BID ADDENDUM #2

Nanuet Union Free School District 103 Church Street Nanuet, NY 10954

Nanuet Bond Projects Phase 3

Date: June 23, 2023

1. Sheet BM-A100-LOWER LEVEL FLOOR PLAN AND ENLARGED ELEVATOR PLANS

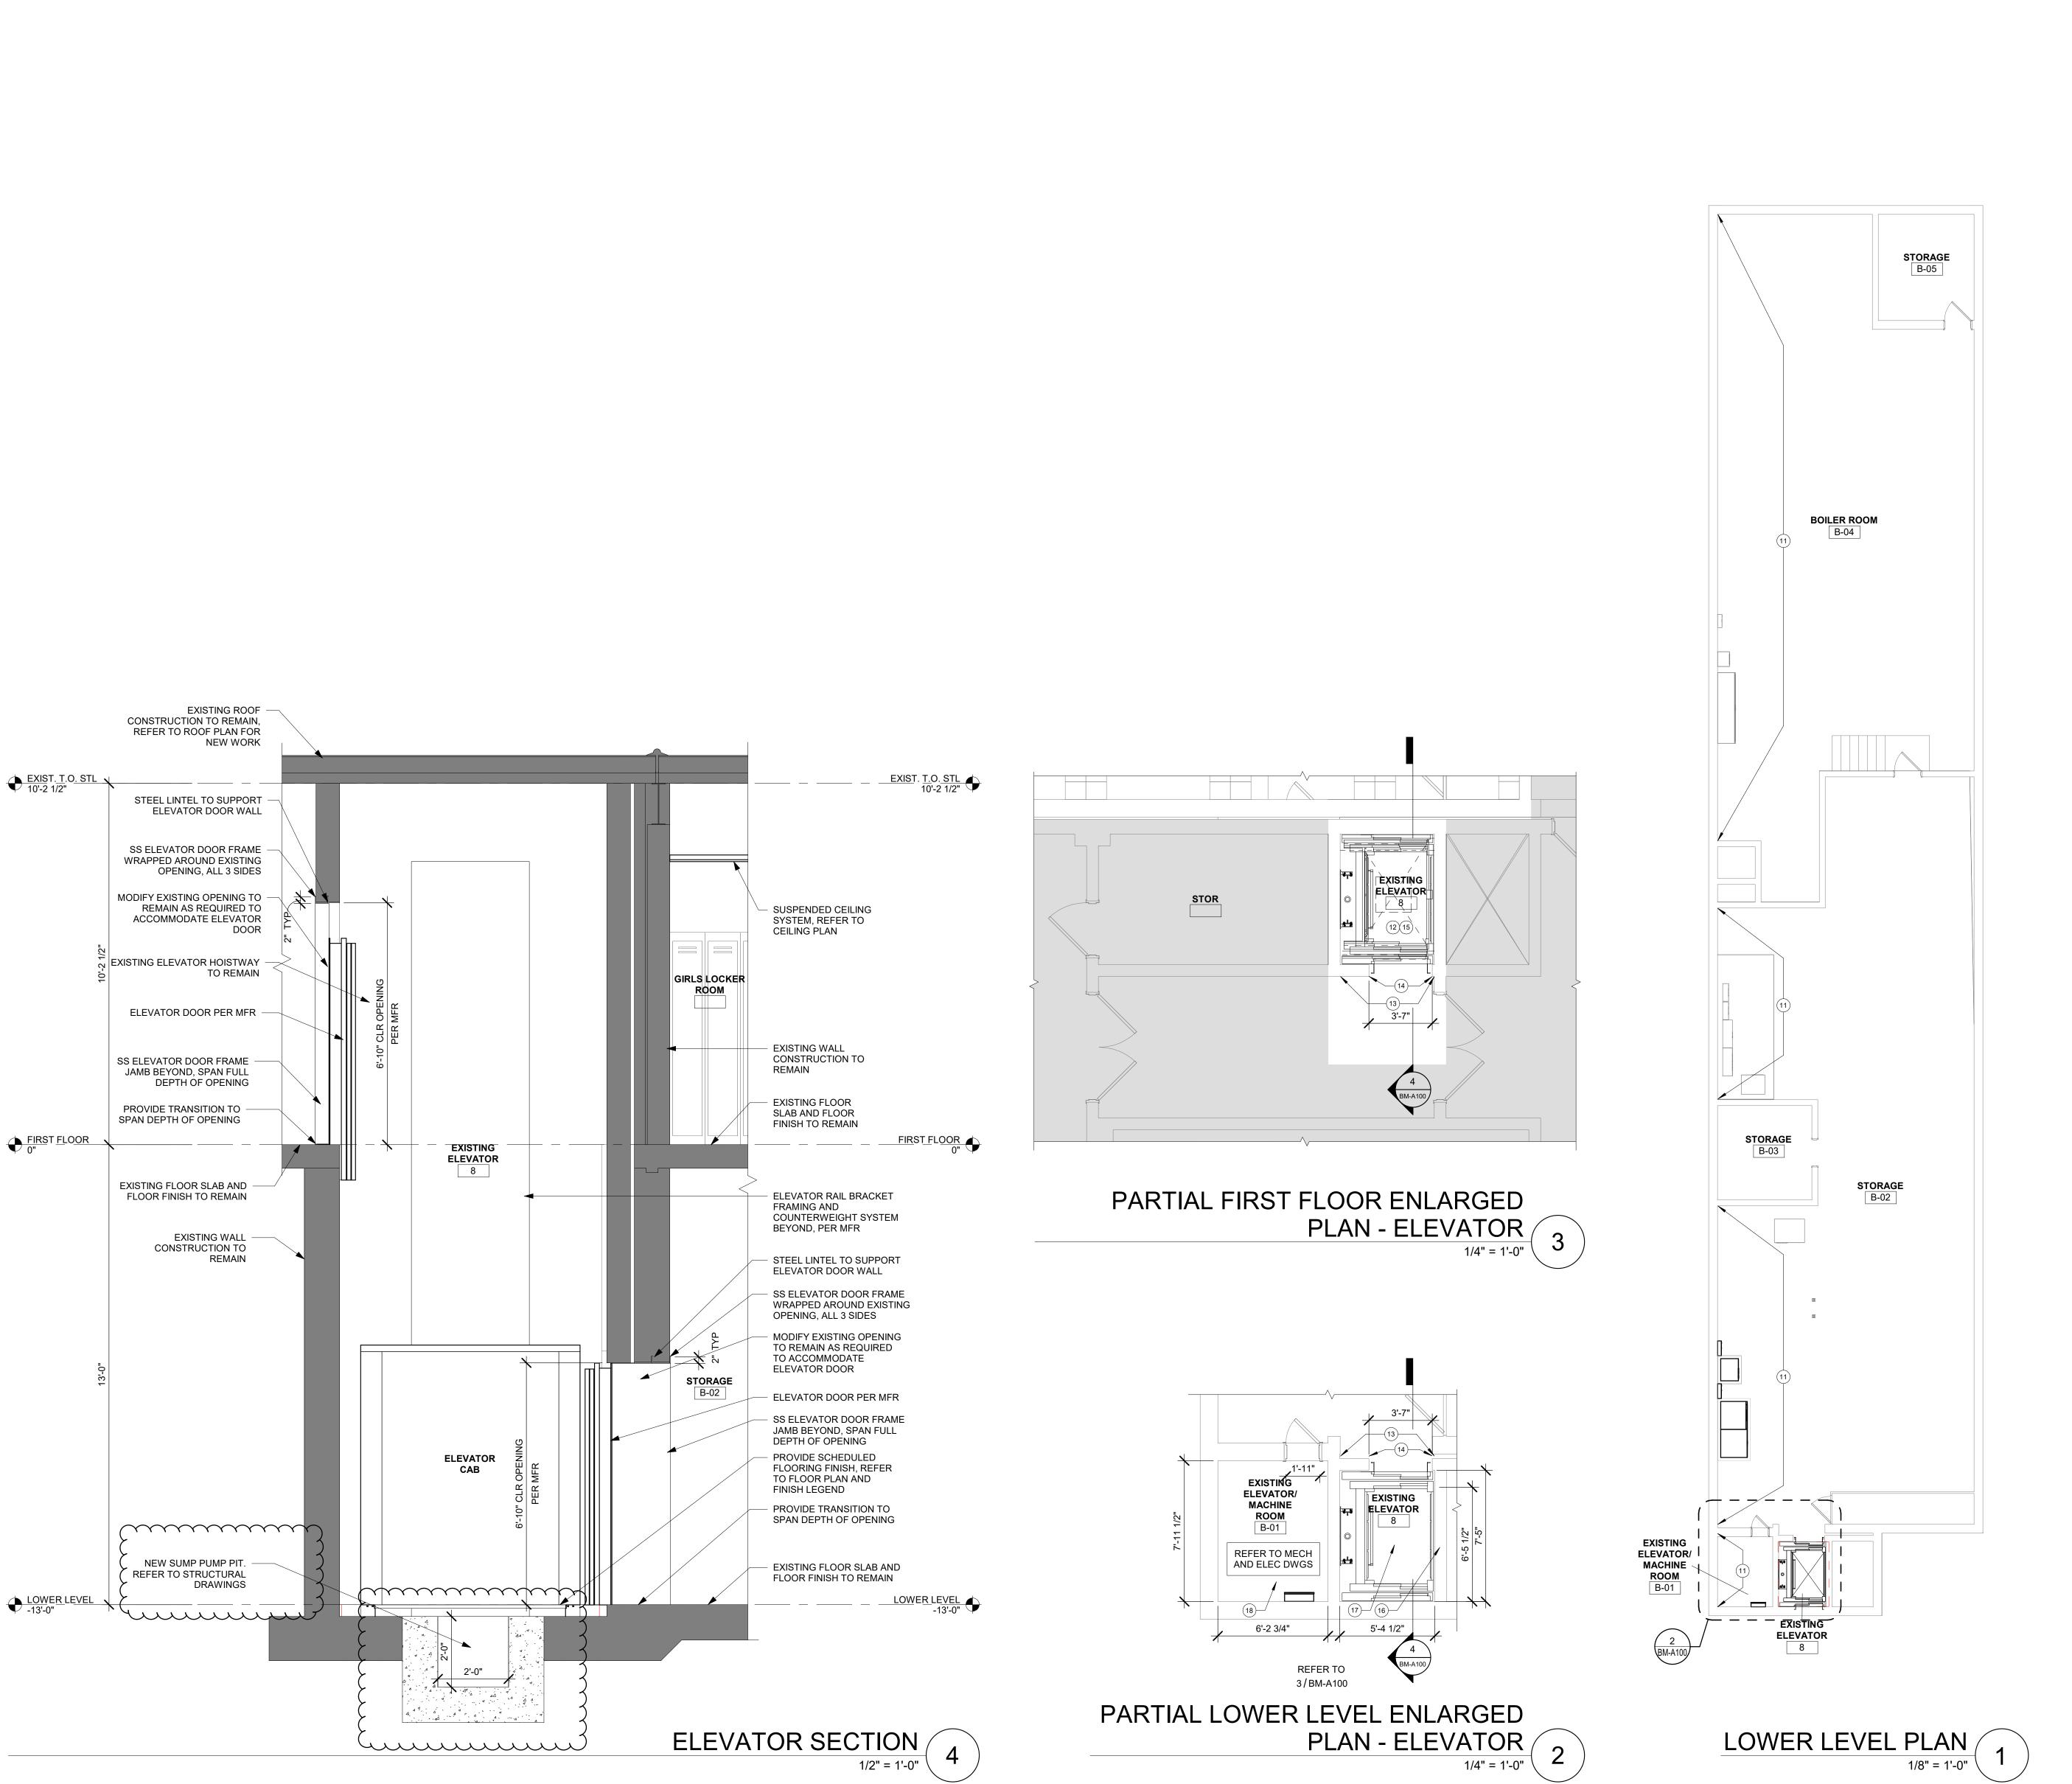
a. Graphical errors corrected on drawing.
